ADMINISTRATIVE SITE PLAN REPORT & DECISION

Project Name: RHA Glennwood Townhomes

File Number: LUA11-054, SA-A

SITE PLAN
Site Lighting

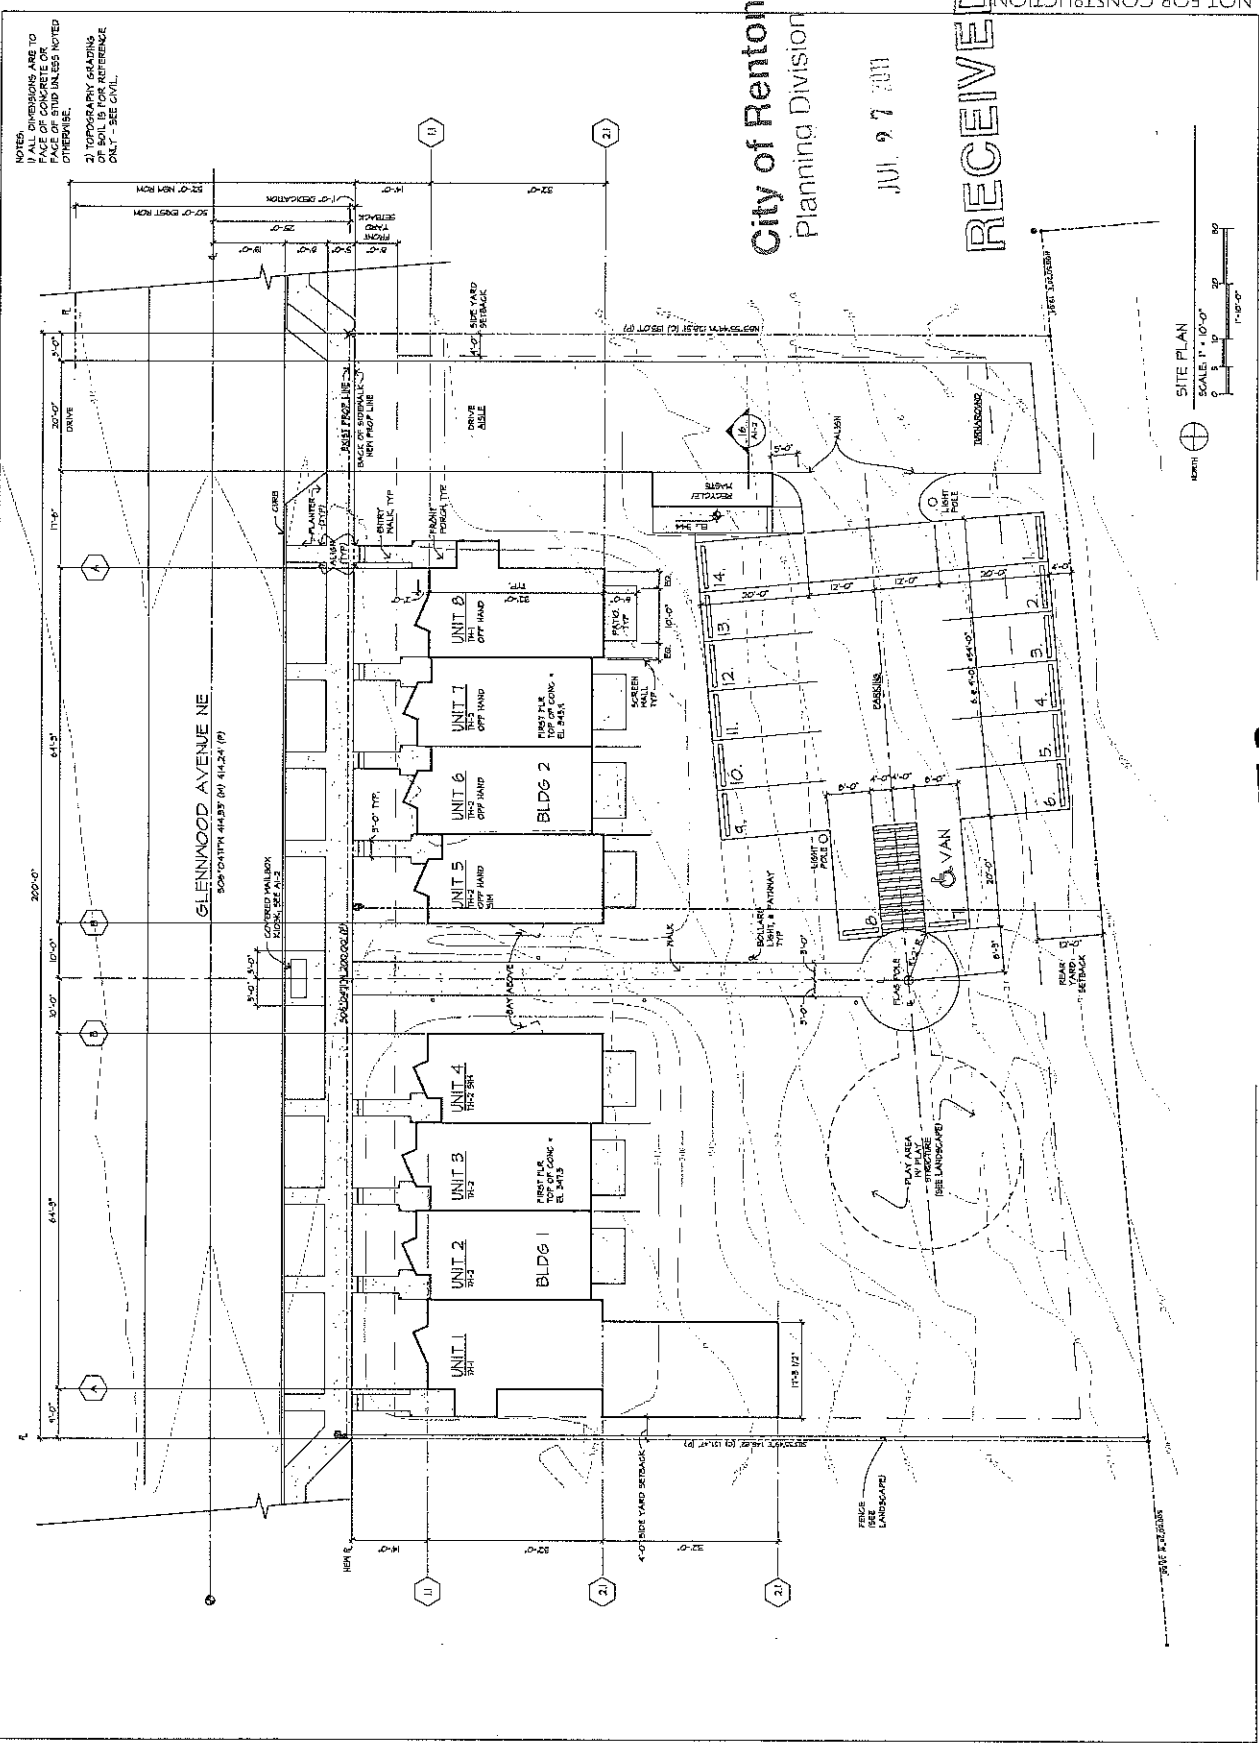
The proposal includes an extension, of Unit #1, to the west beyond the rest of the structure's western façade plane in order to accommodate ADA accessibility for the end unit. The extension frames the common green space and does not contain any meaningful articulation or breaks in the façade or glazing. Windows should represent a significant amount of the facade of a home when facing a common space, they amplify the sense that the community is oriented to people. In order to provide a visual break and create visual interest the following condition of approval is recommended: The applicant shall incorporate either articulation on the southern façade of the extended portion of Unit #1, or as an alternative provide glazing, along the same facade, in combination with enhanced landscaping abutting the façade. The applicant shall submit to, and have approved by, the Current Planning Project Manager, the revised elevation and landscaping plan prior to or concurrent with building permit approval.

The applicant is proposing a predominately 6-foot tall fence along the northern property line. It does not appear a similar fence is proposed along the southern property line. As a condition of approval the applicant would be required to construct an identical fence along the south property line. A revised landscape plan shall be submitted to and approved by the Current Planning Project Manager prior to or concurrent with the building permit approval.

3. The applicant shall incorporate either articulation on the southern façade of the extended portion of Unit #1, or as an alternative provide glazing, along the same facade, in combination with enhanced landscaping abutting the façade. The applicant shall submit to, and have approved by, the Current Planning Project Manager, the revised elevation and landscaping plan prior to or concurrent with building permit approval.

4. The applicant shall construct a fence, identical to the fence proposed on the north property line, along the south property line. A revised landscape or fence detail plan shall be submitted to and approved by the Current Planning Project Manager prior to or concurrent with the building permit approval.

1785.02
PLANTING PLAN

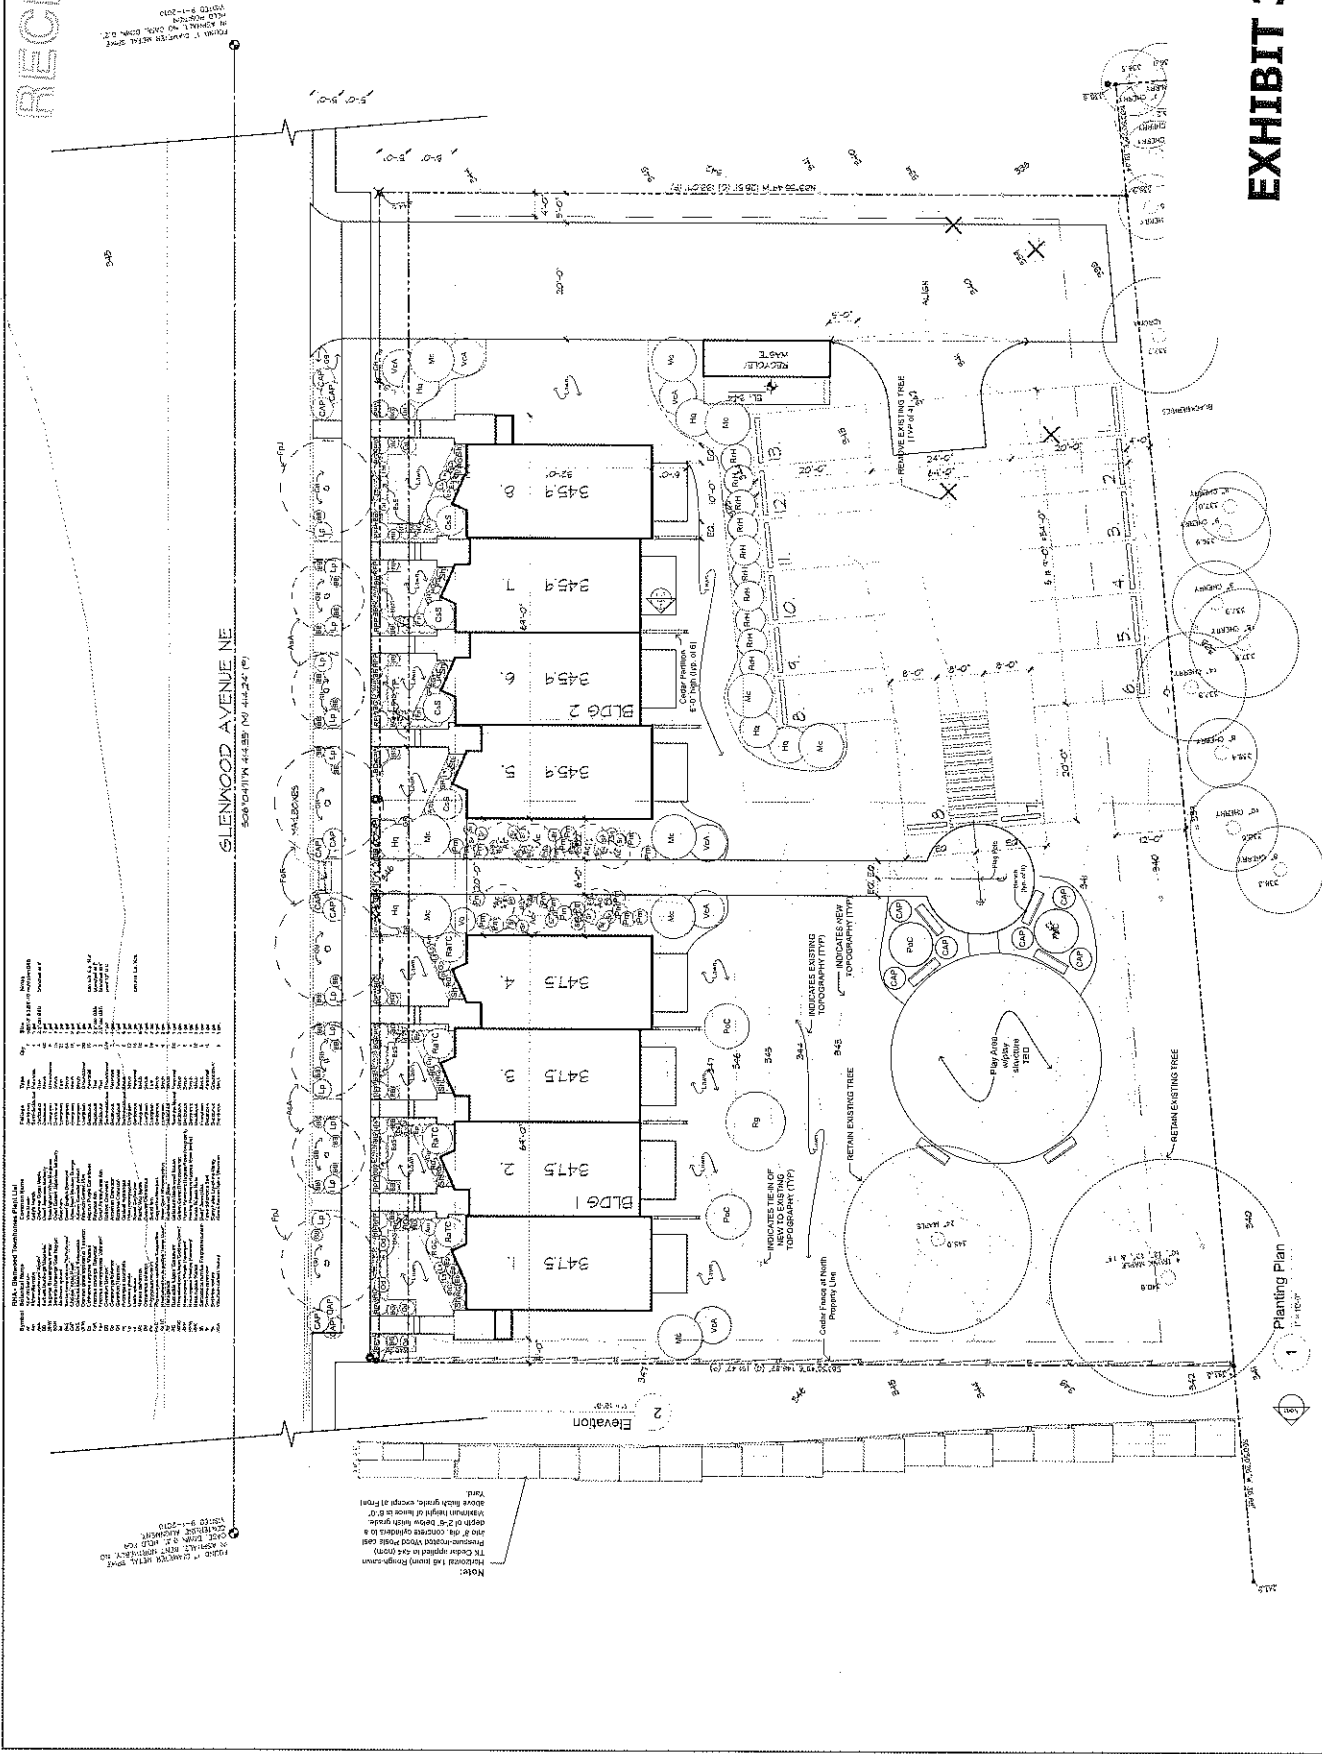
The landscape plan includes a planting plan; the proposed tree species largely consist of vine maple, sugar maple, Raywood ash and Pennsylvania ash trees. The shrubs proposed largely consist of: dwarf English boxwood, dwarf Japanese barberry, and Aztec pearl Mexican orange. Groundcover would consist of firewitch garden pink, starry false lily-of the-valley, and biokovo cranesbill. Conditions of approval, related to landscaping within the Design Review table below, if complied with, the landscape plan would provide visual relief, define areas of pedestrian circulation, and add to the aesthetic enjoyment of the area. Therefore the modification for a reduction in width from 10 to 8 feet along the frontage of the site is approved.

Underground sprinkler systems are required to be installed and maintained for all landscaped areas. The sprinkler system shall provide full water coverage of the planted areas specified on the plan. A revised detailed landscape plan and irrigation plan will need to be submitted at the time of building permit review

The applicant is proposing landscaping around the perimeter of the site and surface parking lot which includes 15 deciduous trees, several shrubs, perennials and groundcovers. The landscape plan includes a planting plan; the proposed tree species largely consist of vine maple, sugar maple, Raywood ash and Pennsylvania ash trees. The shrubs proposed largely consist of: dwarf English boxwood, dwarf Japanese barberry, and Aztec pearl Mexican orange. Groundcover would consist of firewitch garden pink, starry false lily-of-the-valley, and biokovo cranesbill. The proposed landscaping would provide visual relief, define areas of pedestrian circulation, and add to the aesthetic enjoyment of the area. However, the planting plan does not include a mix of evergreen and deciduous trees in order to maintain a tree canopy all year. Therefore staff recommends, as a condition of approval, the applicant submit a revised planting plan depicting a mix of evergreen and deciduous trees on site. The revised planting plan shall be submitted to and approved by the Current Planning Project Manager prior to building permit approval.

2. The applicant shall submit a revised planting plan depicting a mix of evergreen and deciduous trees on site. The revised planting plan shall be submitted to and approved by the Current Planning Project Manager prior to building permit approval.

| 1785.02 | BUILDING ELEVATIONS |

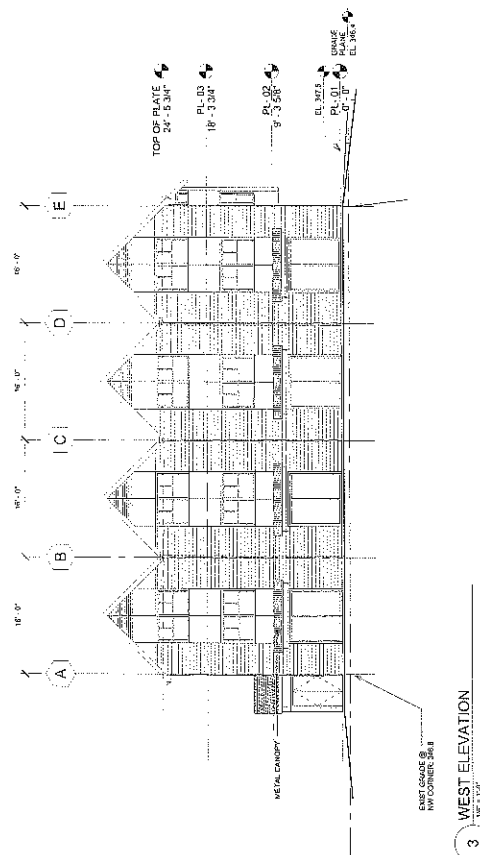
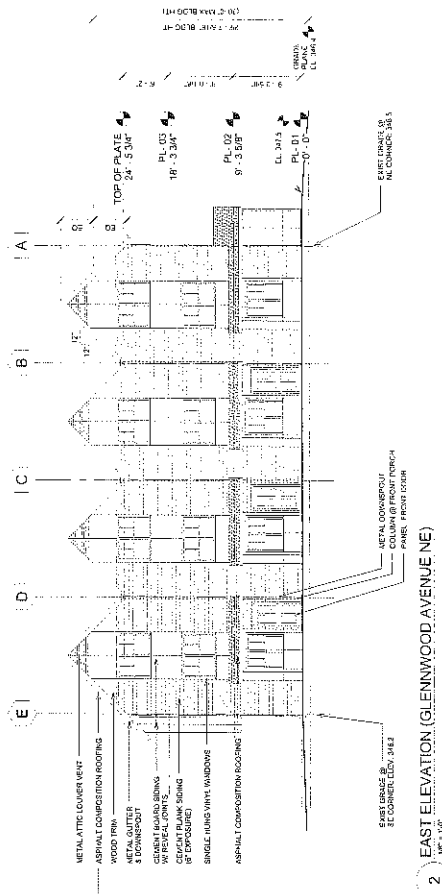
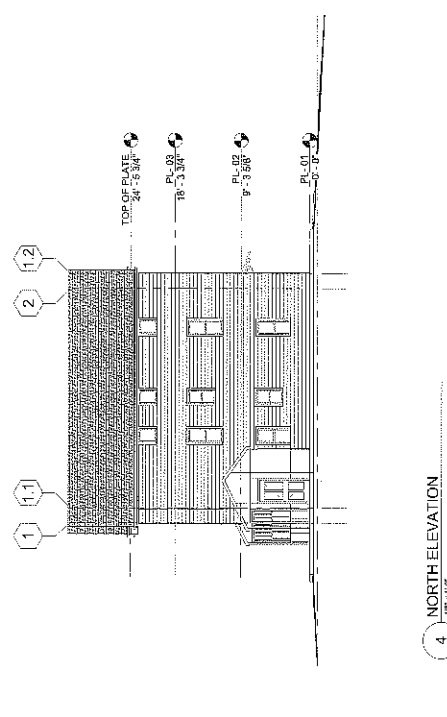
The scale, height and bulk of the proposed buildings are appropriate for the site. The two structures have been limited to a front façade width of 64 feet. Outboard units in each building have been set back 2 feet to reduce the building scale and mass. The roofs are articulated with steep pitches that scale down the building size. Front porches with bays and columns, along with side bays, contribute to the human scale of the building. Exterior light fixtures are also proposed in order to enhance the unit entries (Exhibit 4).

| Not Compliant | Minimum Standard: To differentiate the same models and elevations, different colors shall be used. <i>Staff Comment: A color palette was not provided as part of the Site Plan application materials. As a condition of approval the applicant would be required to demonstrate multiple colors on buildings are provided. A color palette shall be submitted to and approved by the Current Planning Project Manager prior to building permit approval.</i> |

5. The applicant shall demonstrate multiple colors on buildings are provided. A color palette shall be submitted to and approved by the Current Planning Project Manager prior to building permit approval.
